**CONCERNS SOUTH GROUNDWATER
CONTAMINATION PLUME MEETING FEBRUARY
8, 1991**

February 8, 1991, meeting with OEPA concerning the South Groundwater Contamination Plume Removal Action.

Date: February 8, 1991
Place: Offices of OEPA
Subject: South Groundwater Contamination Plume Removal Action:
Part 2 - Groundwater Pumping and Discharge System and
Part 3 - Interim Advanced Wastewater Treatment System (IAWWT)

1989 URANIUM CONCENTRATION COMPARISON

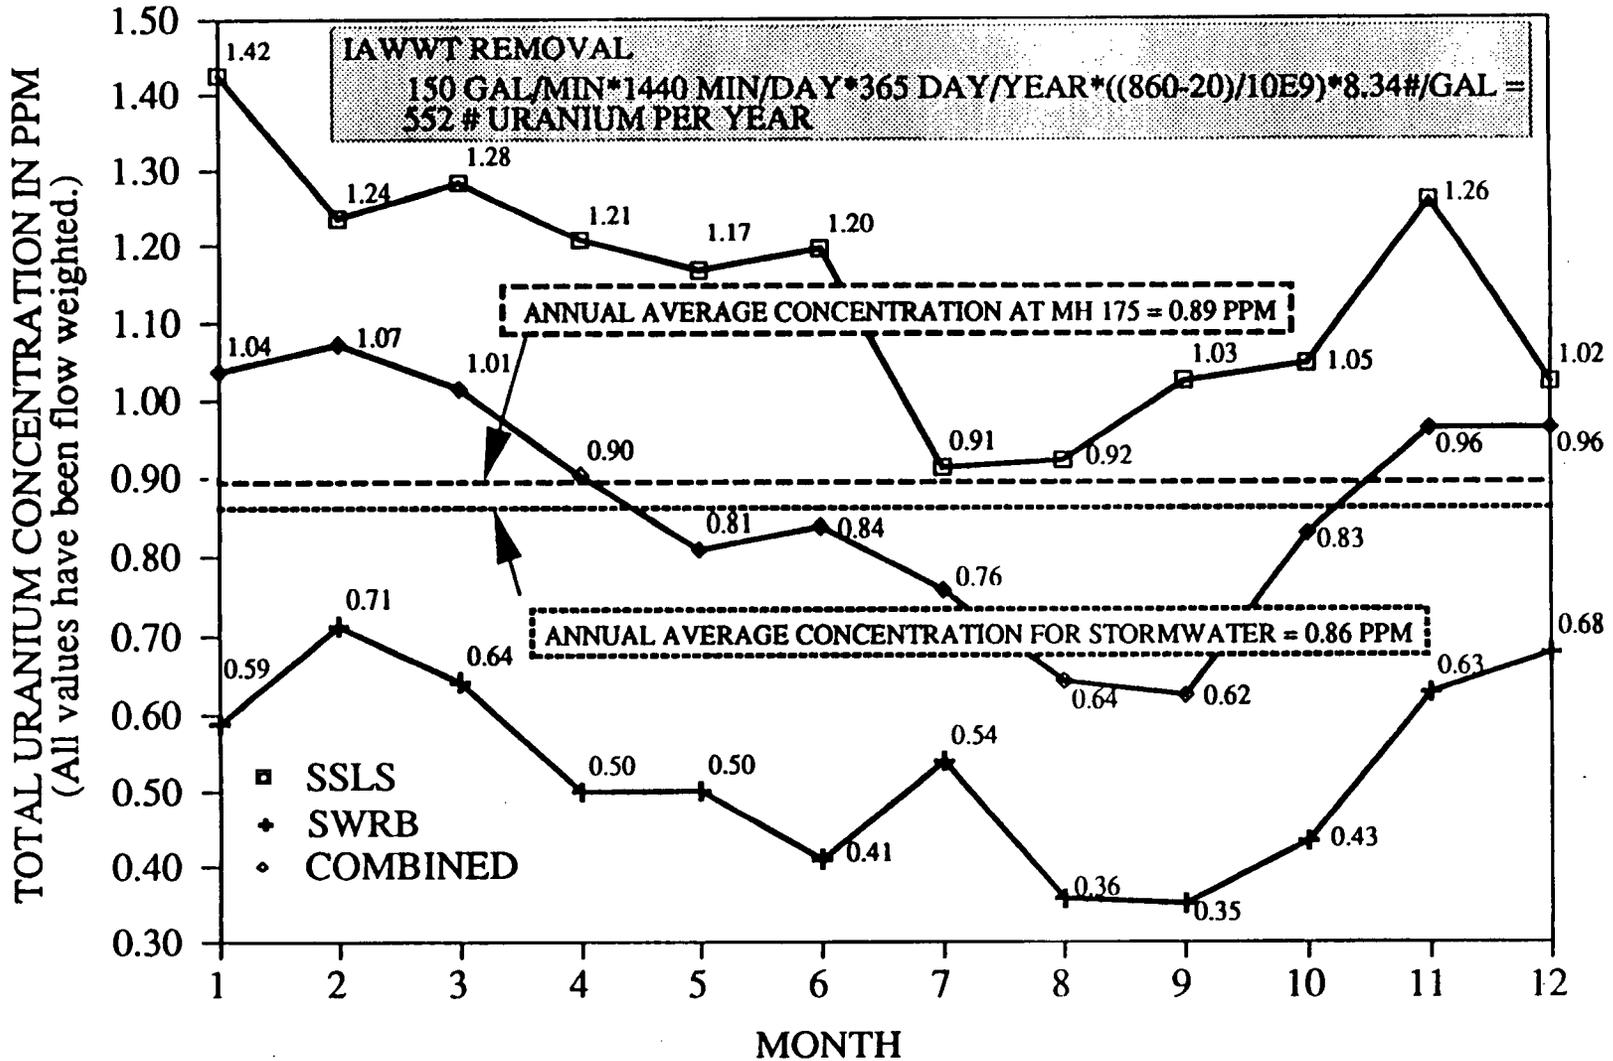
13. Attachment 6 of Enclosure B showed how the combined flow from the SSLS and SWRB would make available enough uranium for removal by the IAWWT as stated in the dispute resolution agreement. The existing Standard Operating Procedure for the SWRB would be revised to ensure that an adequate quantity of stormwater remained for treatment by the IAWWT. WMCO presented the possibility of a new removal action to eliminate SWRB overflows into the Storm Sewer Outfall Ditch by increasing the capacity of the SWRB pump station. It was also explained that an emergency tie-in (locked valve) from the SWRB to the South Plume force main was being planned.

INTERIM ADVANCED WASTE WATER TREATMENT FACILITY

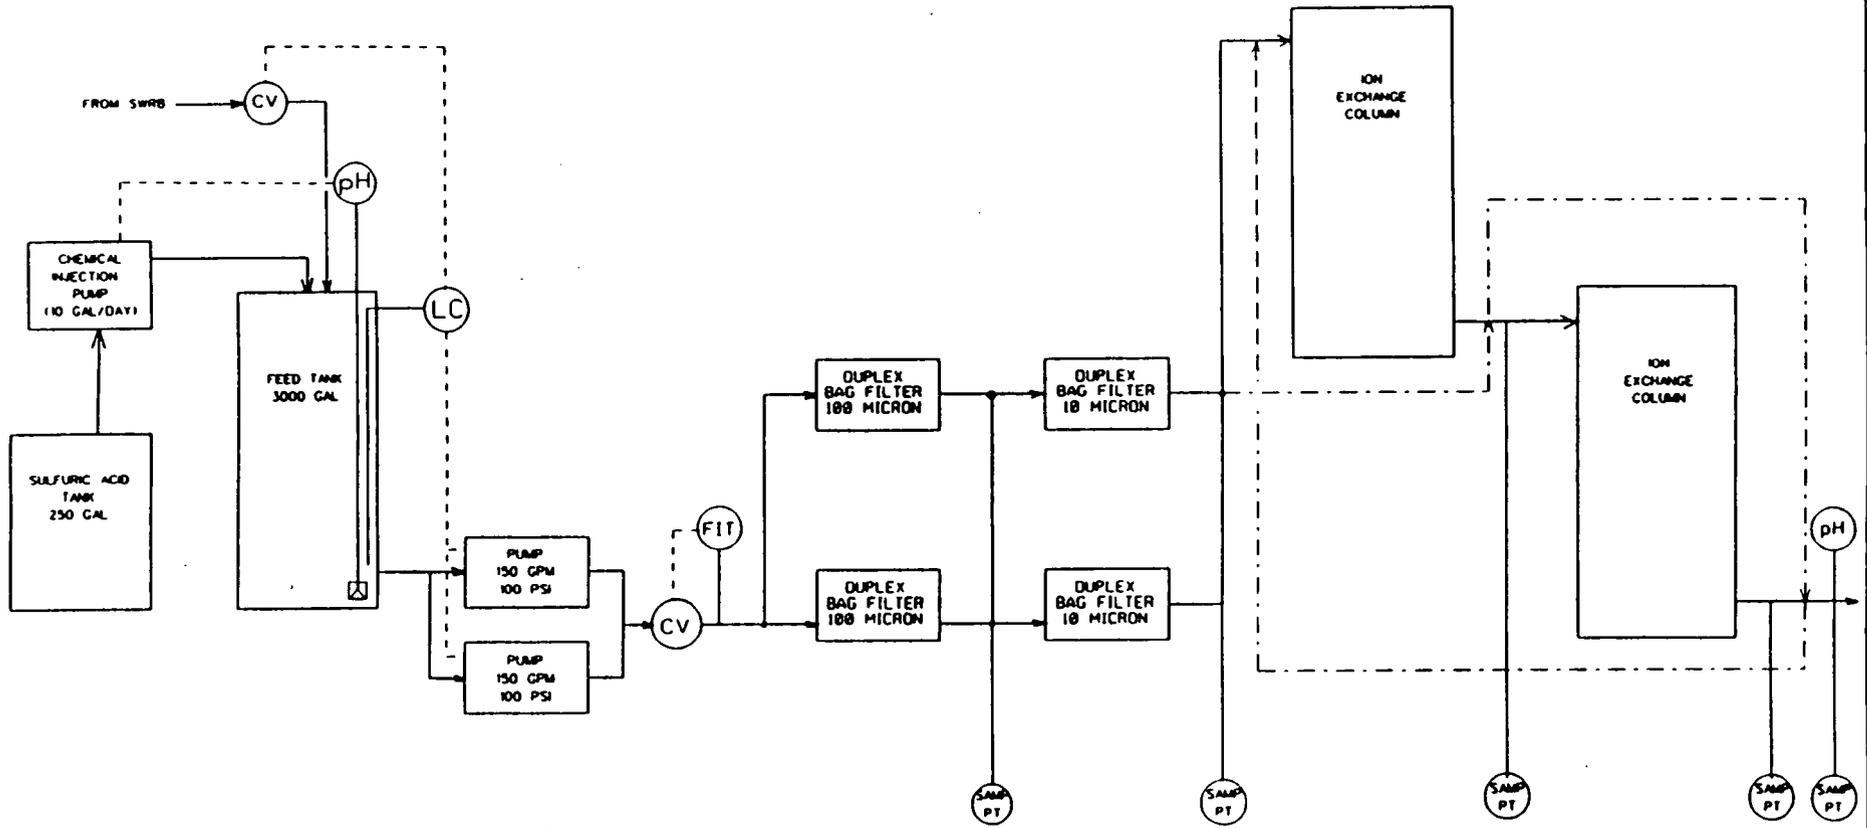
11. The preliminary process and instrumentation drawing for the IAWWT was presented in Attachment 7 of Enclosure B. OEPA responded favorably to this process drawing. It was requested that a pH probe with override (shutdown) of the pumping system be provided prior to the Ion Exchange units. This would protect against any possibility of acid getting through to remove uranium from the resin. (ACTION ITEM)
